October 29, 2002

Enclosed are the results of our analysis of the plans submitted for Building America review at the Sonoran Moon and Sonoran Vista developments. This work includes calculation of design loads, Energy Star scores, energy guarantee figures, and testing goals.

Discussion of ventilation systems for Pulte-Tucson homes

Figure 1 Central-fan-integrated supply ventilation; outside air duct into ceiling return box

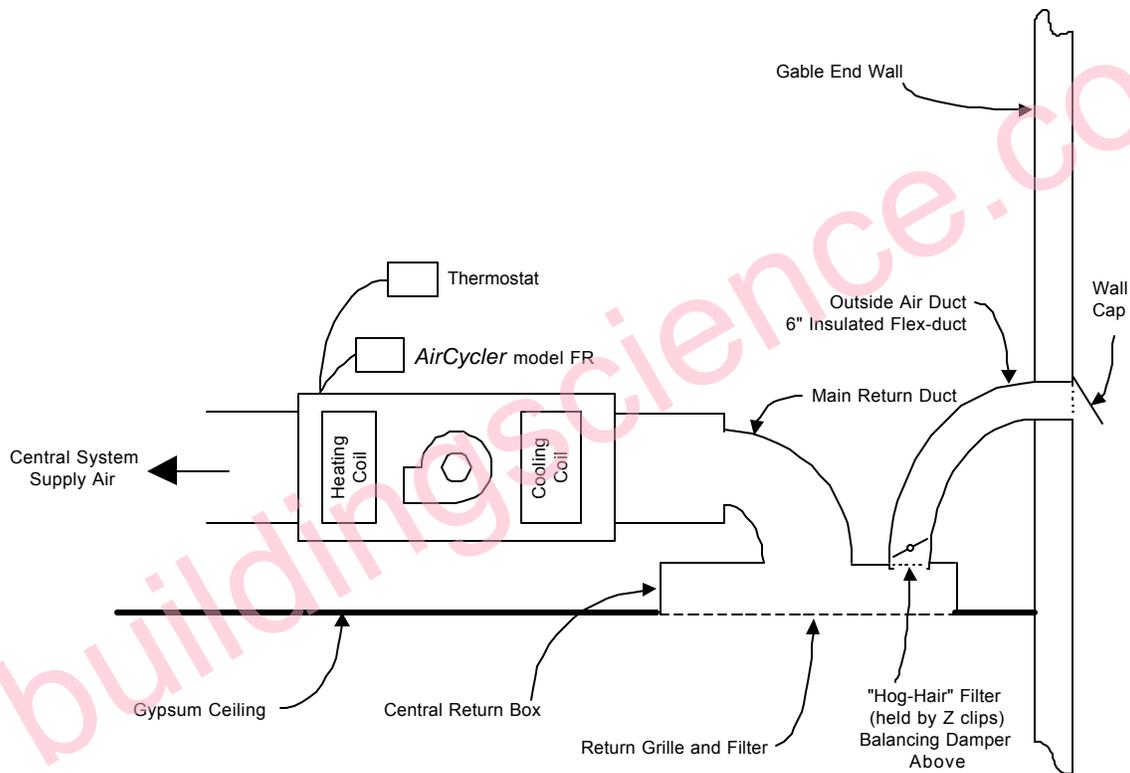
According to reports from the field (Bill Irvine and Len Utt), the outside air duct pressures were usually between -5 and -10 Pa with respect to outside, giving at least one-third less outside air flow than required. The low outside air duct pressure was likely due to how the duct was connected to the air handler return system. The system was specified to have a single ceiling return filter grille box with the outside air duct connected to the box, with a washable hog-hair-type filter held in place by a Z channel. Refer to Figure 1.

It appears that, in some cases, up to three return grilles were being installed. This leaves less flow, and hence, less available negative pressure available at the main return grille where the outside air duct is connected. Further, the return grille should be sized for 350 ft/min. Sizing the return for more than 350 ft/min could lead to noise problems, and sizing for less reduces the available negative pressure to draw in outside air.

Figure 2 Central-fan-integrated supply ventilation; outside air duct into extended collar

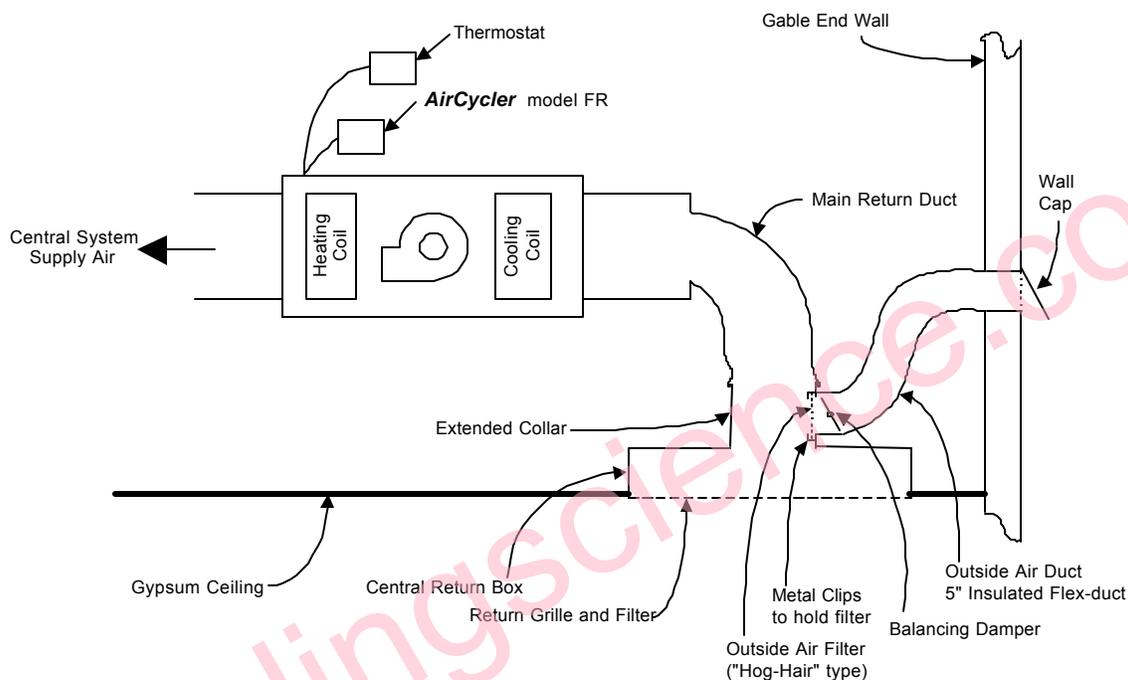
An alternative connection point that would always assure enough draw for outside air would be to connect the outside air duct to an extended collar where the main return flex duct connects to the return box. Refer to Figure 2.
